Approved Section 4.55 (.....2.....) Modification Application

Project
BARANGAROO STAGE 1B
PUBLIC DOMAIN
Modification S4.55

Drawing Title
WATERMANS QUAY
DETAIL PLAN - TREES

Drawing Title
BARANGAROO AVE NORTH
DETAIL PLAN - NO TREES
Drawn
SS

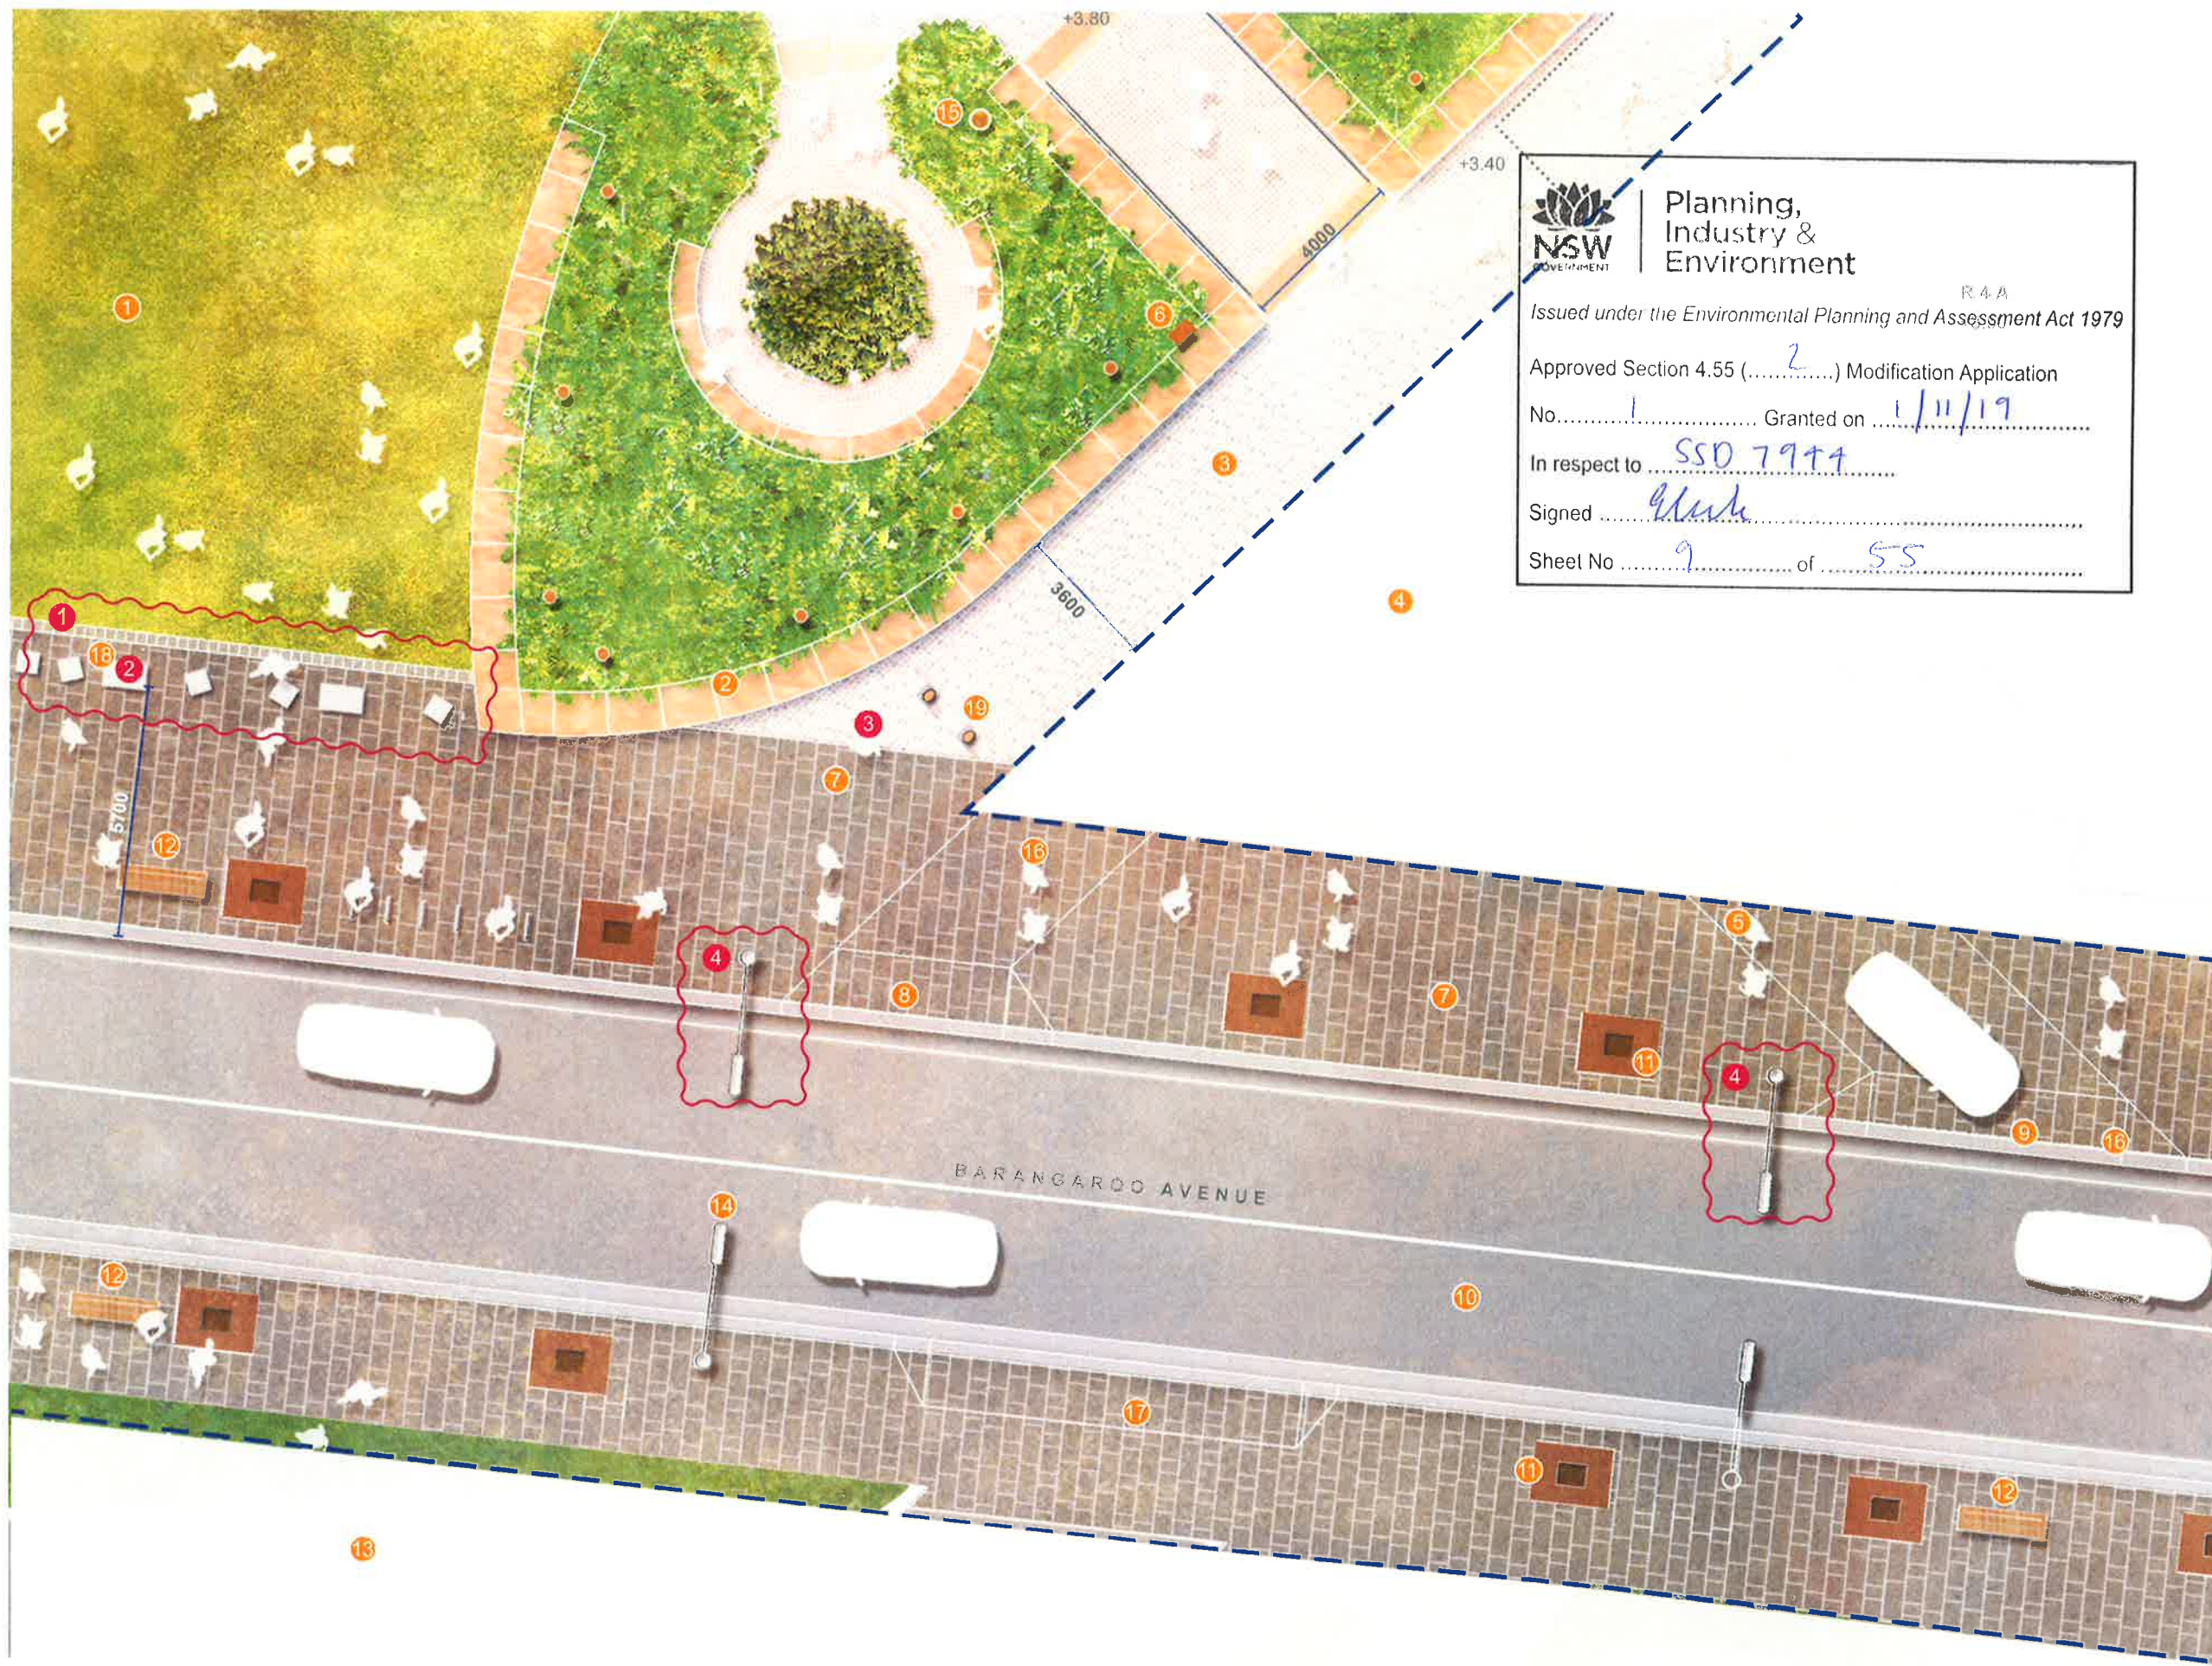
- Proposed Modifications**
- Amendment cloud
 - 1 Sandstone paving strip changed to City of Sydney paving along Hickson Park
 - 2 Sandstone bollards changed to concrete & setout amended.
 - 3 Remove porphyry paving to City of Sydney transition as per consent requirement B23
 - 4 Additional smart pole

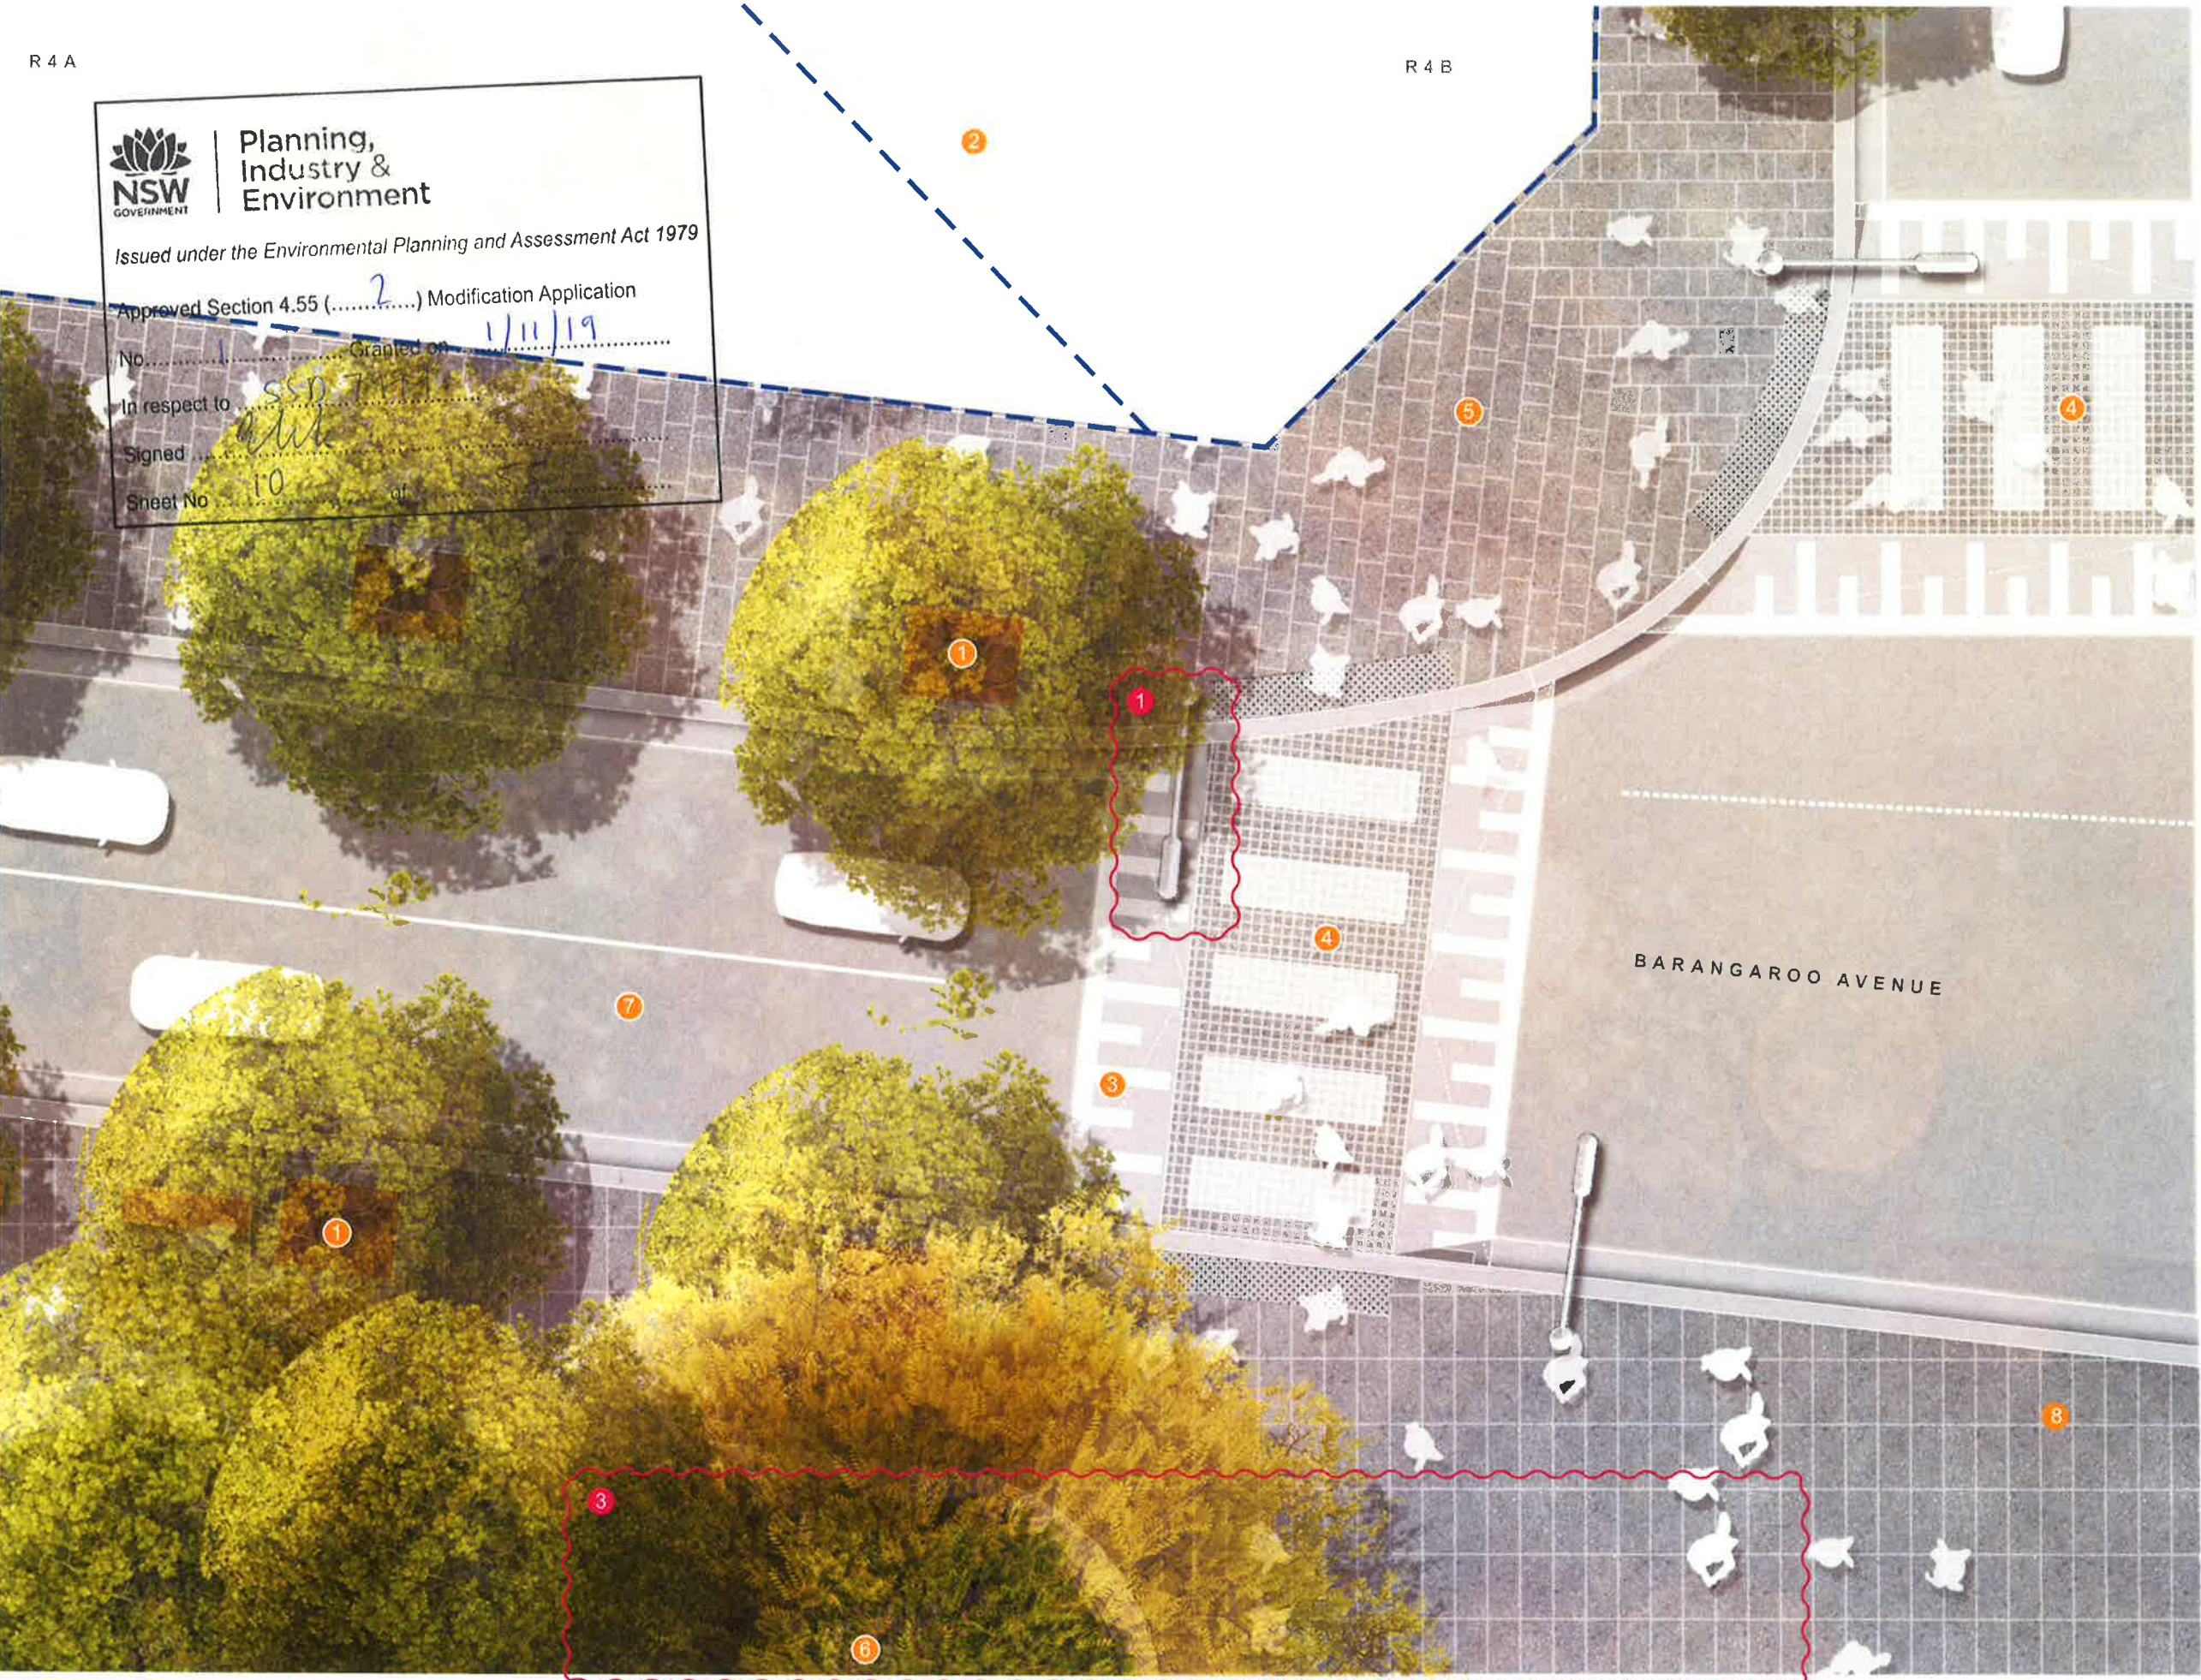
- Proposed Modifications**
- Amendment cloud
 - 1 Additional smart pole
 - 2 Not in use
 - 3 Relocated Fig tree to North raised planter

Drawing Title
BARANGAROO AVE SOUTH
DETAIL PLAN - NO TREES

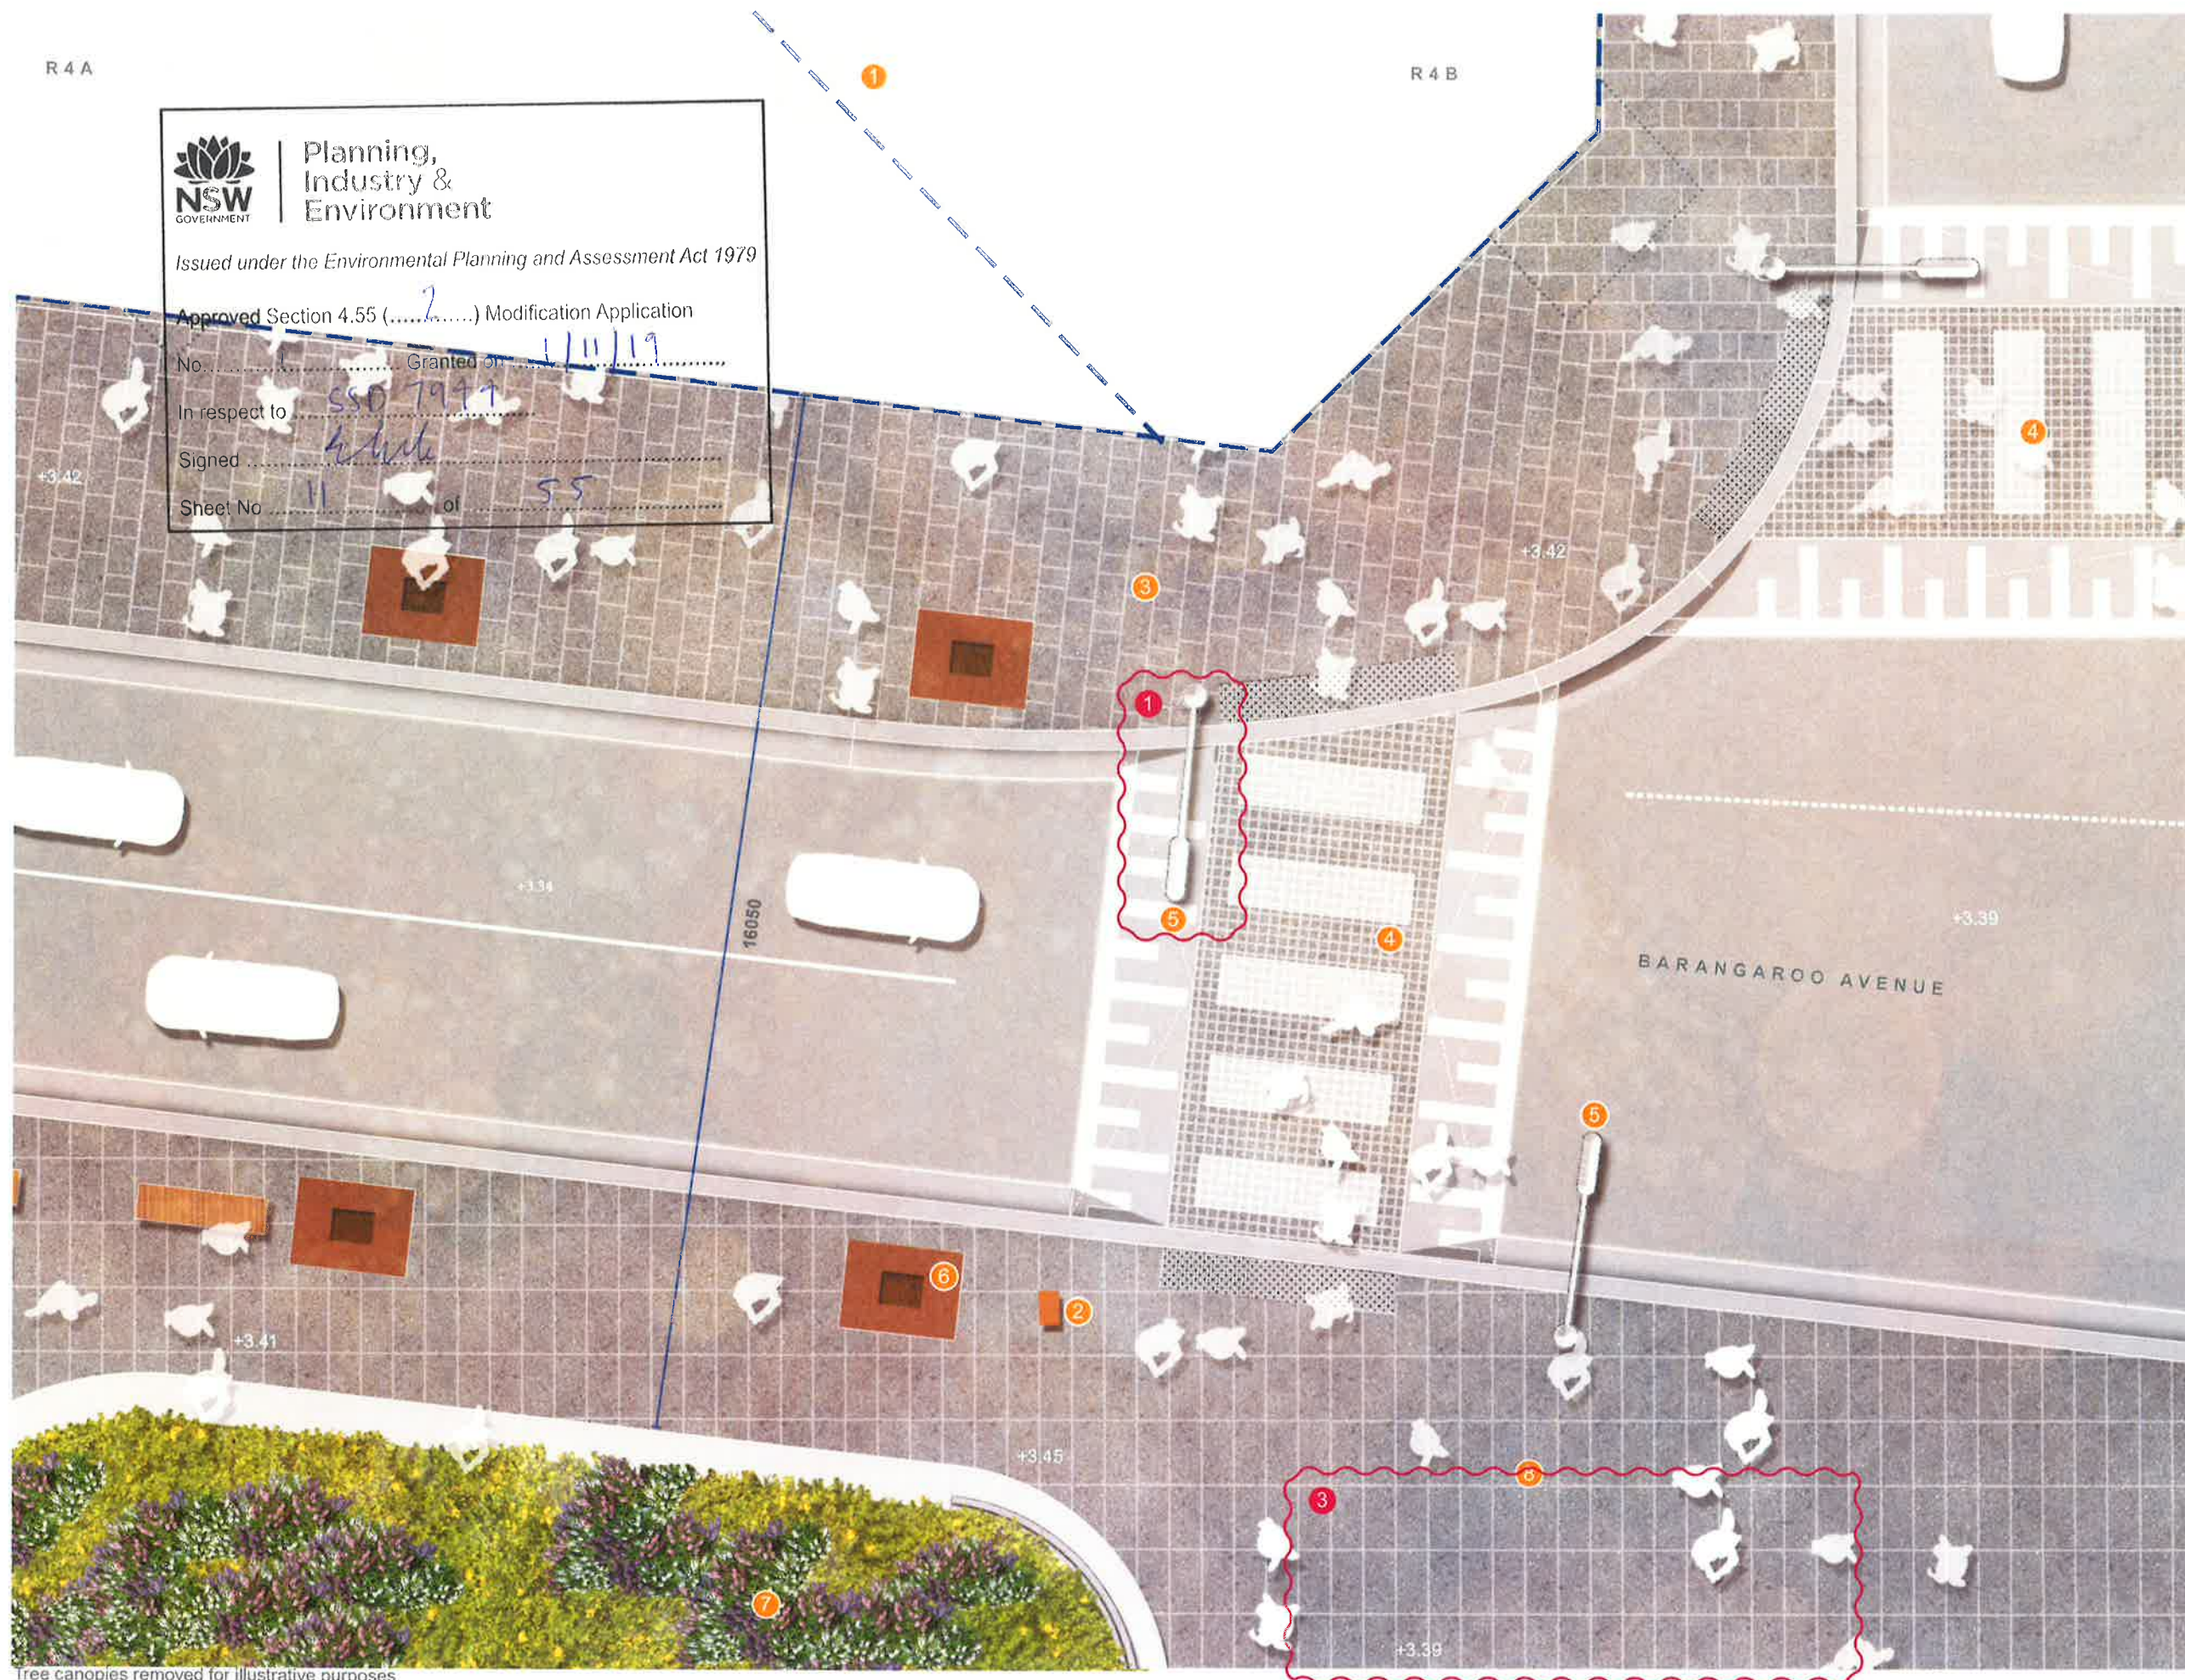
- 1 Additional smart pole
- 2 Not in use
- 3 Relocated Fig tree to North raised planter
